**Total Maximum Daily Load (TMDL) Study
For Waterbodies in the Vicinity of the I-93 Corridor
from Massachusetts to Manchester, NH:**

Dinsmore Brook in Windham, NH

April 18, 2008

**PREPARED BY
PHIL TROWBRIDGE, P.E.
WATERSHED MANAGEMENT BUREAU**

Figure 2: Time Series of Temperature, Chloride, Stream Flow and Chloride Export at Station I93-DIN-01

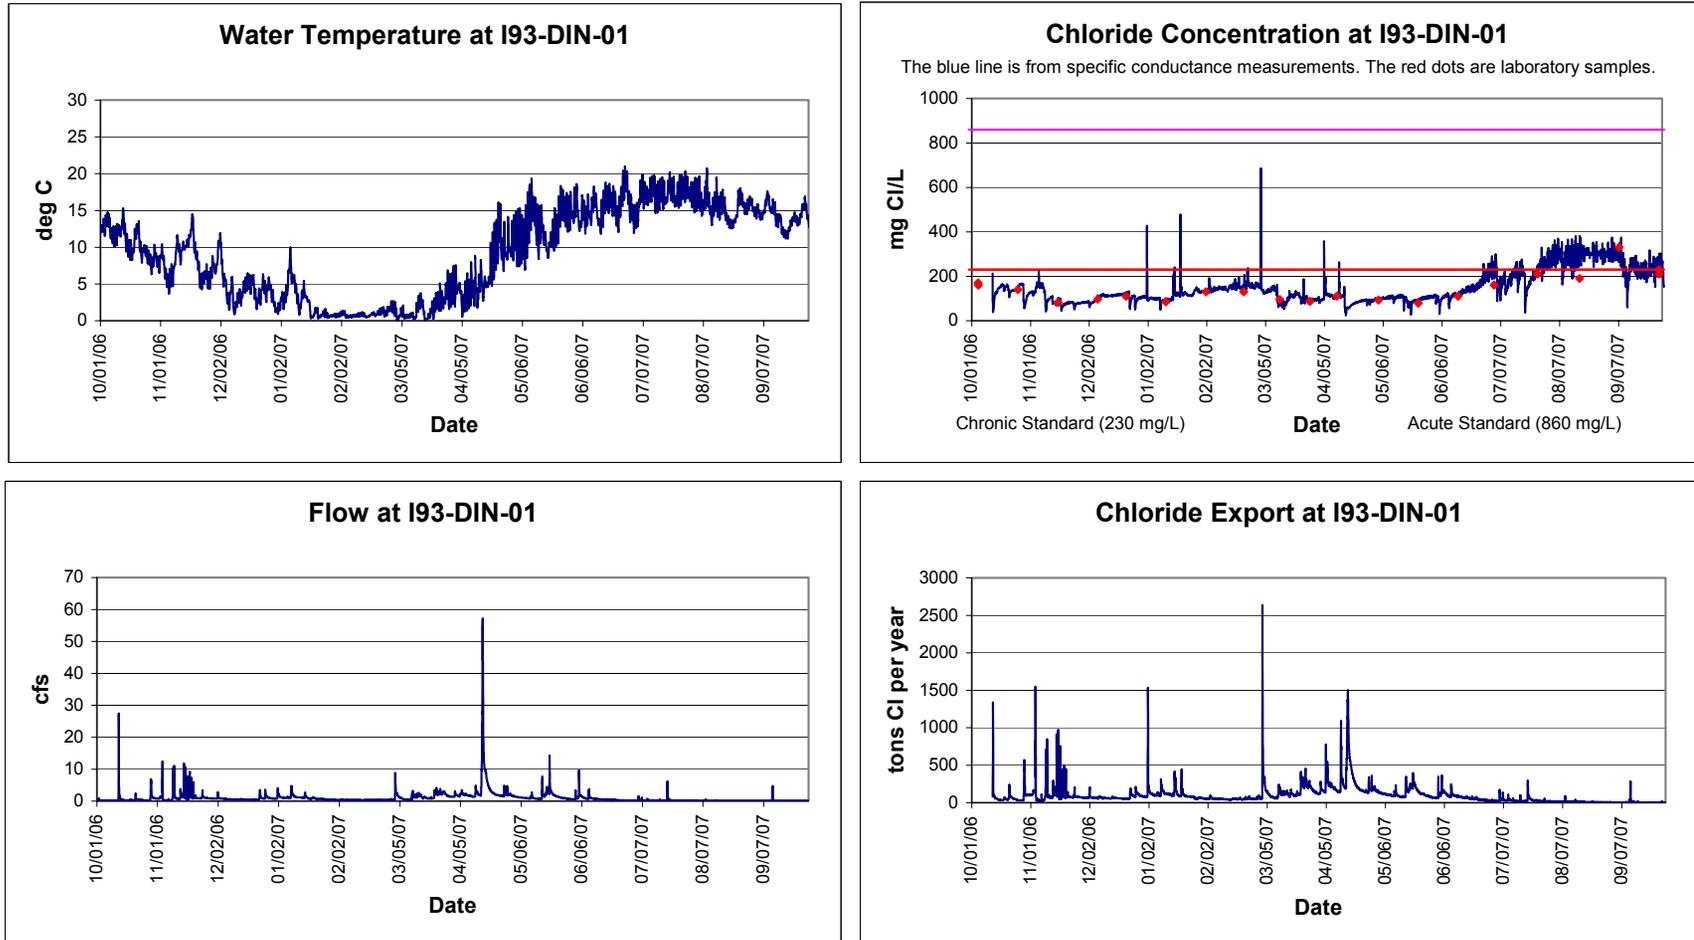
- 3.1 The relationship between specific conductance and chloride concentrations is not accurate for the summer low flow period for which violations of the water quality standard were observed.

Response: DOT claims that the same mechanisms that caused the 2006 dry season data at station I93-DIN-01 to be rejected appears to recur in 2007. This is not the case. For the low flow period of between July 15 and October 15, there were 5 paired measurements of chloride and specific conductance in both 2006 and 2007. In 2006, all five of the paired measurements failed the quality control tests (DES, 2007a, Table 9). In 2007, only one of the five pairs failed the tests (DES, 2007a, Appendix B). Therefore, the data collected during the low flow period in 2007 was considered valid for the TMDL, while the 2006 data was not.

DOT characterizes the 2007 low flow period as the “period for which the regression calculated chloride concentration is 128 mg/L greater than the laboratory measured chloride concentration”. In fact, this claim only applies to one of the five pairs of chloride and specific conductance measurements. This pair failed the quality control test as noted above; however, four other pairs passed the test during the same period. DES used the regression equation between specific conductance and chloride from the Quality Assurance Project Plan for all of the Dinsmore Brook measurements. DES did not use a separate regression equation for the low flow period at this station.

DOT argues that during low flow periods “ions will be induced to migrate to the terminals by the electric current emitted by the terminals themselves. Without any flow to flush the ions away from the probe, the readings will increase and become more erratic until there is an event to flush the ions away.” The data collected at this station does not support this claim. For the one pair of specific conductance and chloride measurements that failed the quality control test, the cause of the failure appears to be from ionic stratification in the water column, not the attraction of ions to the probe. A hand-held meter measured specific conductance near the datasonde when the chloride sample was collected. If ions had been slowly attracted to the datasonde under stagnant conditions, we would expect that a hand-held meter, freshly inserted into the water, would read a different value. In fact, the hand-held meter and the datasonde measured similar values 1,108 and 1,028 uS/cm, respectively.

Figure 5: TMDL Load Duration Curve at Station I93-DIN-01

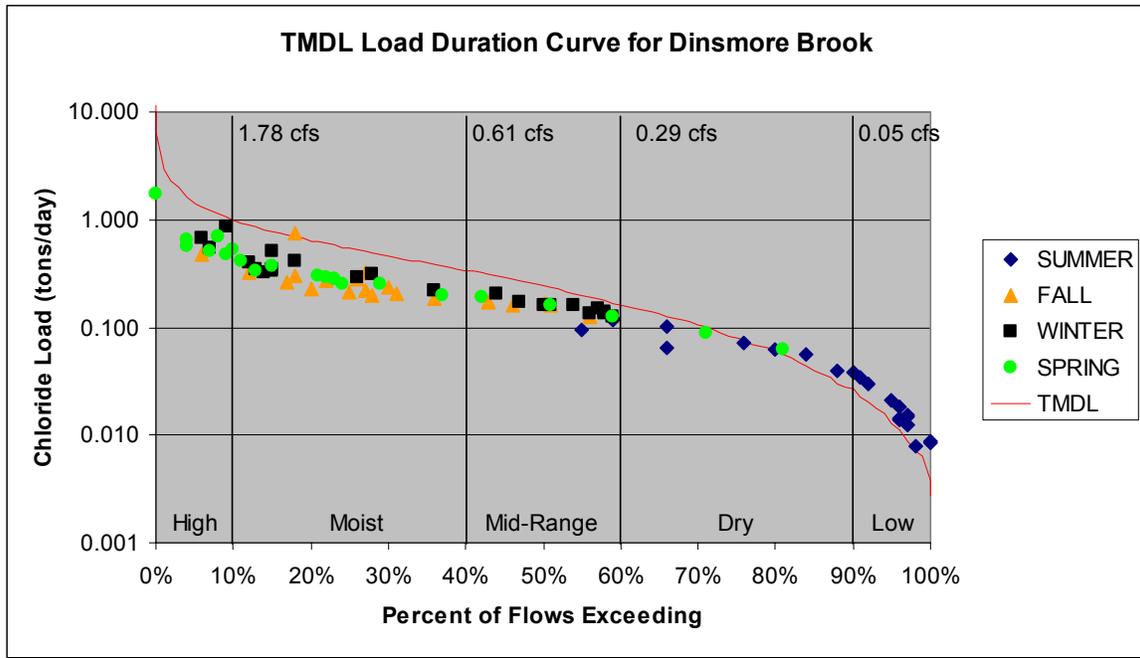
2.5 The TMDL should be based on chloride concentrations during the low flow hydrologic condition, not the dry hydrologic condition.

2.7 The TMDL should be established with daily load allocations, not yearly.

3.1 The TMDL should not be based on the percent reduction goal relative to FY07 because FY07 was a mild year.

Response: The official TMDL for this study is the load duration curve shown in Figure 5. This curve covers all hydrologic conditions. The alternative expression of the TMDL used data from the dry hydrologic condition to approximate the salt reductions needed to guide implementation. EPA guidance (EPA, 2007) advises against using the low flow hydrologic condition for such an alternative expression of the TMDL because of the small sample size for these conditions. Regardless, the official TMDL is expressed for all flows, including low flow hydrologic conditions.

Response: For this study, the TMDL, wasteload allocation, and load allocation are shown on the load duration curve shown in Figure 5. The units for this curve are tons of chloride per day, which meets the requirements of expressing the load allocations as daily loads.

Response: The official TMDL is the load duration curve in Figure 5. The TMDL is not based on FY07 conditions, but rather on a twenty-year flow record. The source of the confusion is Table 5. The allocation of loads in Table 5 is an alternative expression of the TMDL to aid in developing the implementation plan. The percent reduction values were
